This document created by the Florida Department of Business and Professional Regulation - 850-487-1824

Total Mods for Structural in Pending Review: 171

### Sub Code: Building

FIGURE 1410.3(1)
SINGLE-SPAN VINYL OR ALUMINUM SOFFIT PANEL SUPPORT

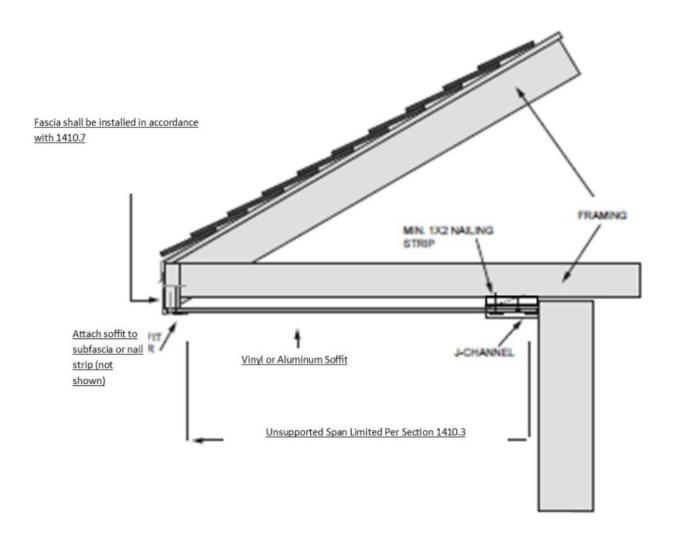
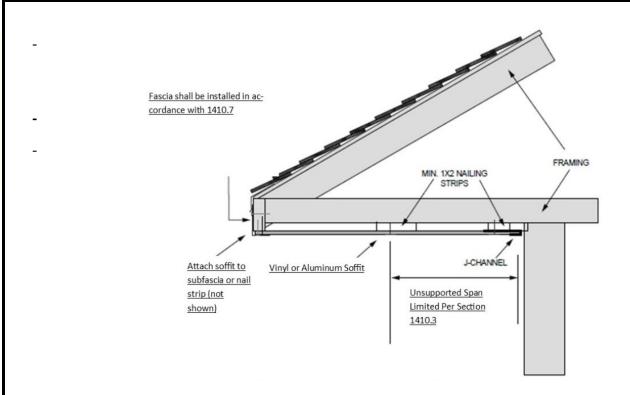
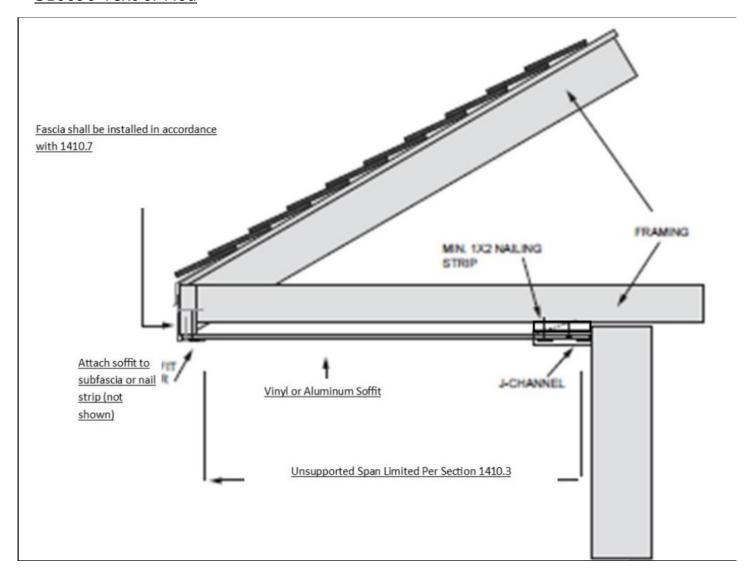
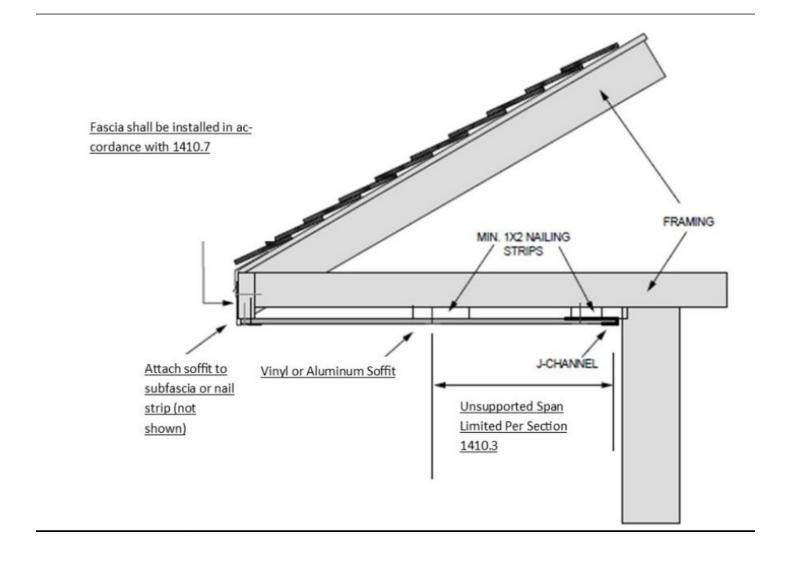
(renumber existing Section 1410 as Section 1411)

FIGURE 1609.3(1)

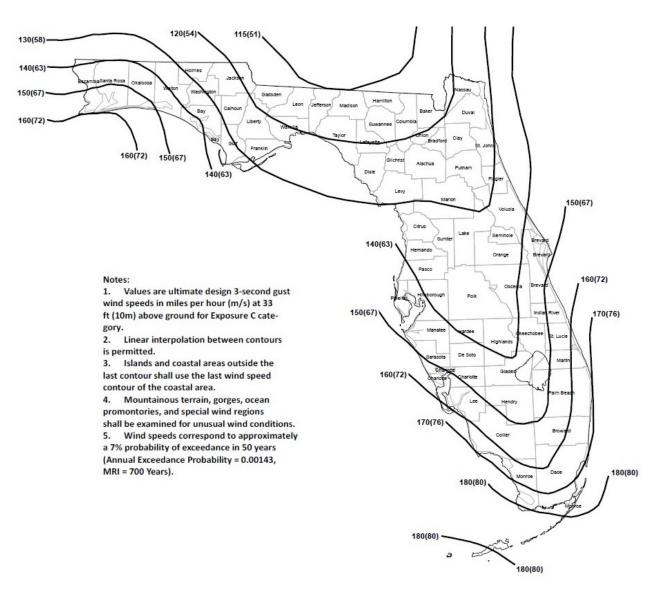
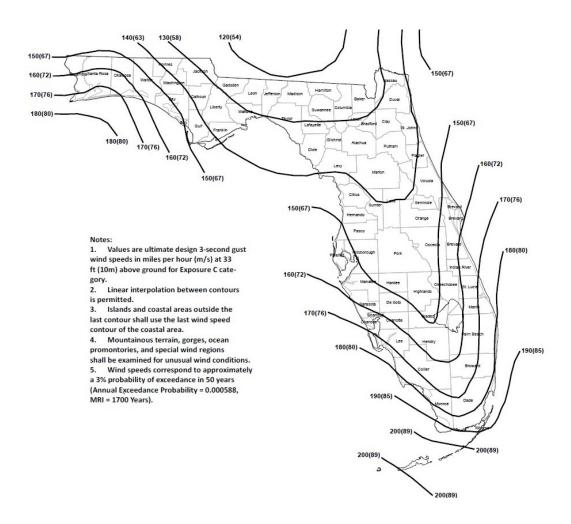
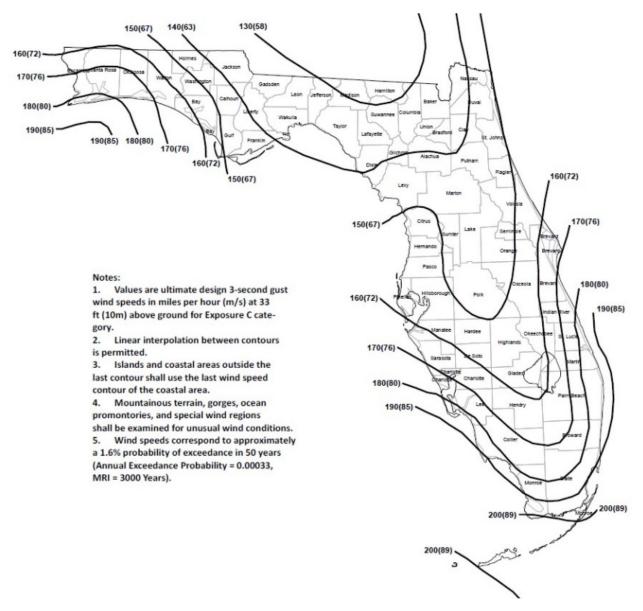
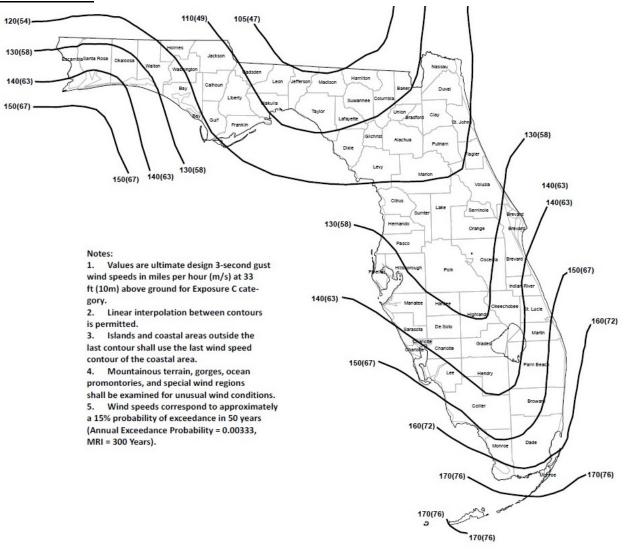
## Delete Figures 1609.3(1), 1609.3(2), 1609.3(3), 1609.3(4) and replace with the following:

- Slight increases in design wind speeds for the western Panhandle.
- Revised the determination of applicability of the Wind-borne Debris Region in areas where the design wind speed is greater than or equal to 130 mph and less than 140 mph.
- Changes to roof pressure coefficients for mean roof heights less than or equal to 60 ft.
- · New provisions for roof pavers
- New provisions for ground-mounted fixed-tilt solar panel systems.
- New provisions for wind loads on elevated buildings (MWFRS and C&C).
- · New provisions for tornado loads.

For most of Florida, wind speeds have not changed. However, for the western part of the Panhandle, wind speeds have slightly increased. The following figure shows the impact of these increases for Risk Category II. The 130 mph contour has shifted very slightly northward and eastward. The 140 mph contour and the 150 mph contour have shifted moderately northward and eastward.

Where wind speeds are equal to or greater than 130 mph but less than 140 mph, the Wind-borne Debris region now applies within one mile of the mean high water line where an Exposure D condition exists upwind of the water line. The term "coastal" has been deleted. This change provides a more consistent method for determining the Wind-borne Debris Region in these areas.

FIGURE R301.2(4)  $\label{eq:ultimate}$  ULTIMATE DESIGN WIND SPEEDS,  $V_{ULT}$

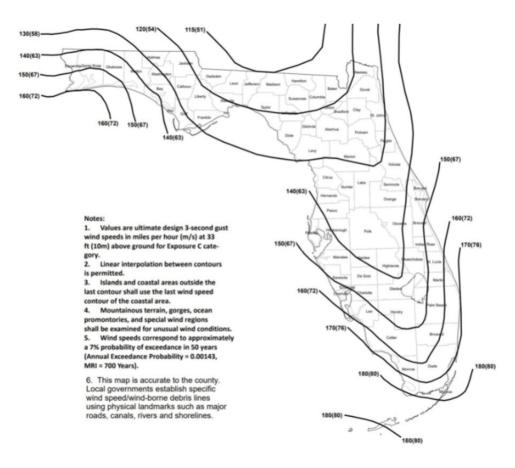
### Delete Figure R301.2(4) and replace with the following:

- Slight increases in design wind speeds for the western Panhandle.
- Revised the determination of applicability of the Wind-borne Debris Region in areas where the design wind speed is greater than or equal to 130 mph and less than 140 mph.
- Changes to roof pressure coefficients for mean roof heights less than or equal to 60 ft.
- New provisions for roof pavers
- New provisions for ground-mounted fixed-tilt solar panel systems.
- New provisions for wind loads on elevated buildings (MWFRS and C&C).
- New provisions for tornado loads.

For most of Florida, wind speeds have not changed. However, for the western part of the Panhandle, wind speeds have slightly increased. The following figure shows the impact of these increases for Risk Category II. The 130 mph contour has shifted very slightly northward and eastward. The 140 mph contour and the 150 mph contour have shifted moderately northward and eastward.

FIGURE R301.2(7)
COMPONENT CLADDING PRESSURE ZONES

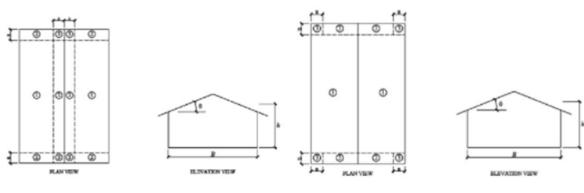
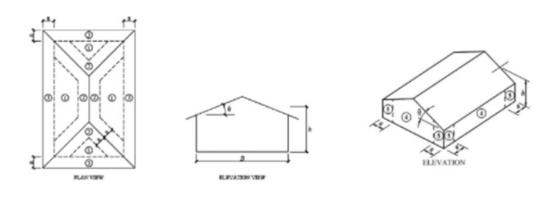
Delete Figure R301.2(7) and replace with the following:

### Figure R703.11.1.4 (1) Typical Starter Strip<sup>a</sup>

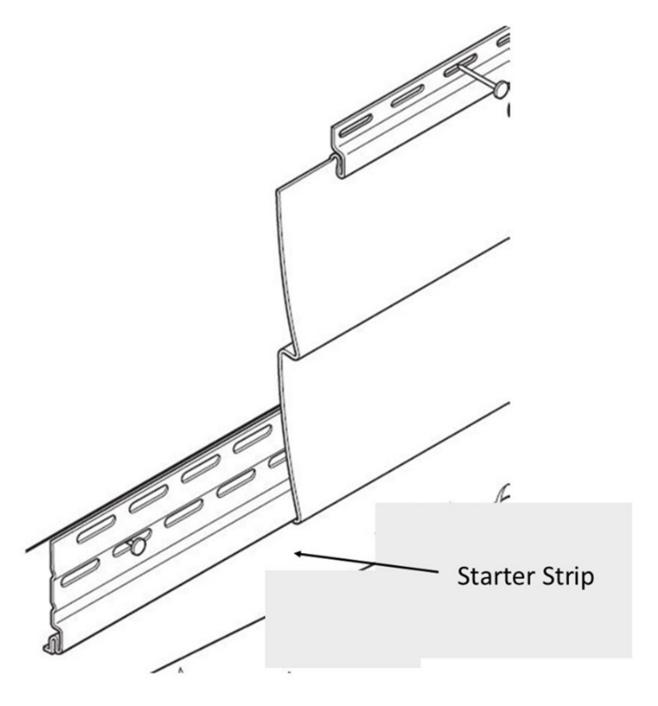
<u>R703.11.1.4 Starter Strip.</u> The first course of horizontal siding shall be secured using a starter strip as specified in the manufacturer's installation instructions. See Figure R703.1.4 (1).

### Figure R703.11.1.5 (1) Typical Snap Lock & Utility Trim<sup>a</sup>

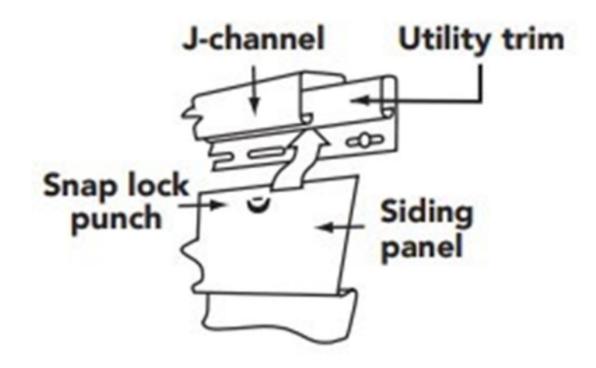
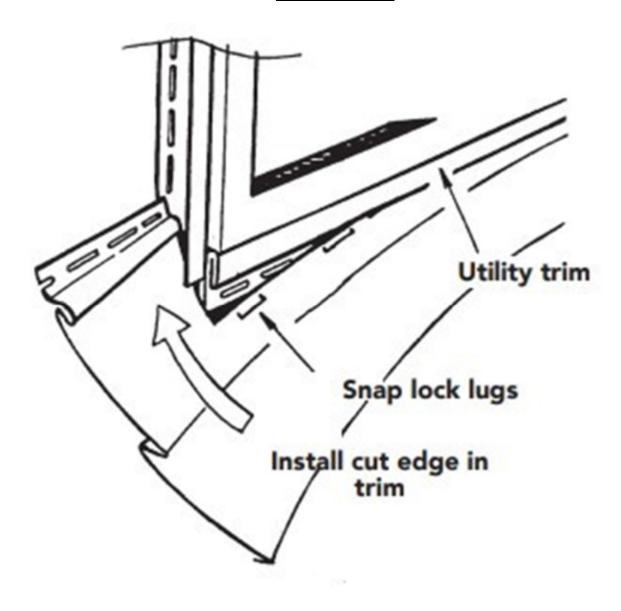
Where horizontal siding has to be cut or trimmed below windows and at the top of walls, the top edge of the siding shall be secured with utility trim and snap locks or as specified by the manufacturer's installation instructions. See Figures R703.11.1.5 (1) and R703.11.1.5 (2).

FIGURE R704.2.1
TYPICAL SINGLE-SPAN VINYL SOFFIT PANEL SUPPORT

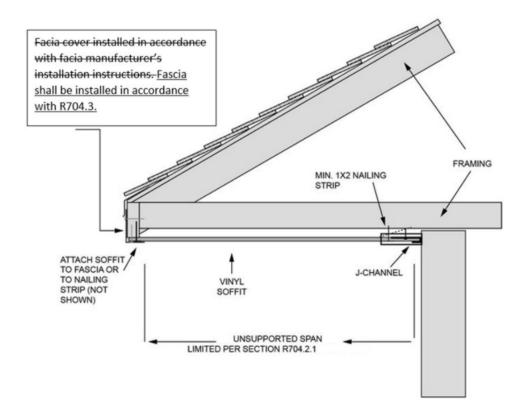
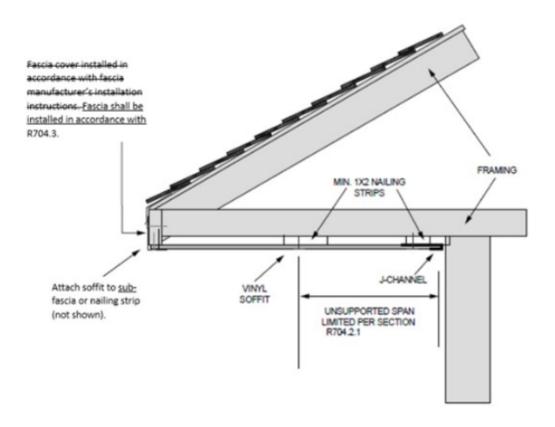
Modify figures and text as follows:

FIGURE R704.2.1(1) TYPICAL SINGLE-SPAN VINYL SOFFIT PANEL SUPPORT

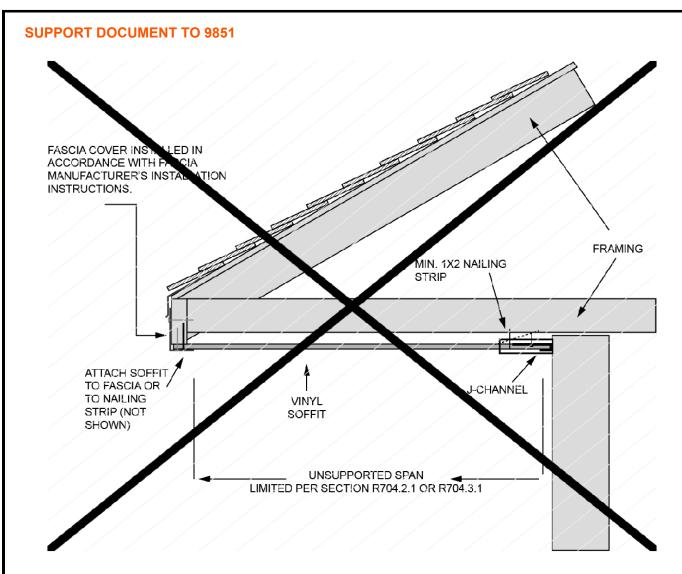
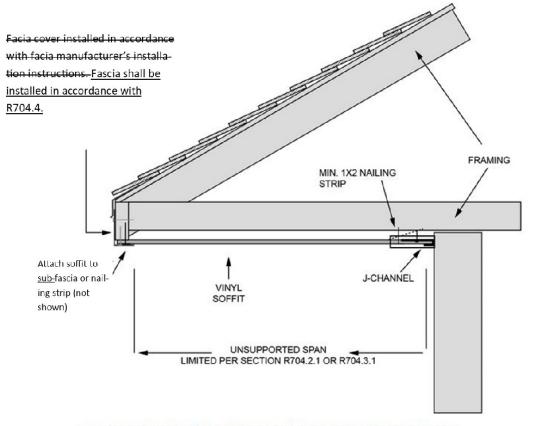
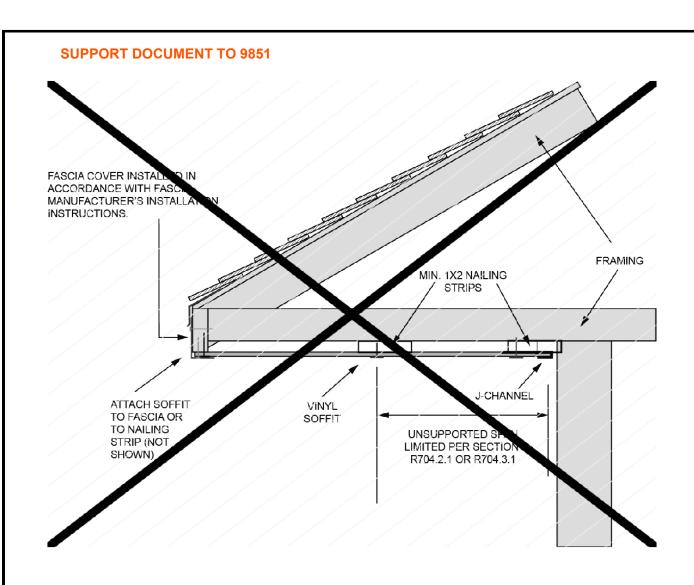
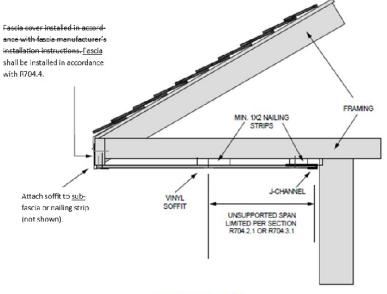
#12 Fascia (8030) IRC: SECTION R703, SECTION R704, FIGURE R704.2.1(1), FIGURE R704.2.1(2), R704.3.1, R704.4 (New)

FIGURE 1

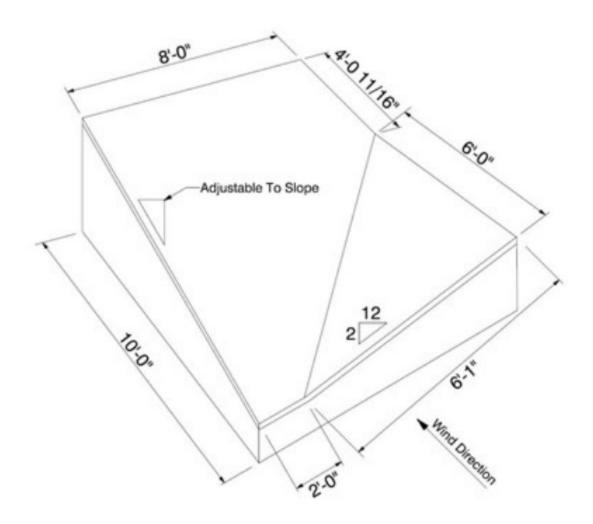
A replacement for Figure 1 is proposed. The new drawing is properly proportioned, includes correct dimensions, and more accurately represents the test deck that is used. Section 8.1.2 is modified to clarify how adjustments to slope are made. Finally, the edition of TAS 100 is updated. TAS 100 has been modified in previous cycles, but the edition was not updated when that occurred.

Replace existing Figure 1 with this version.
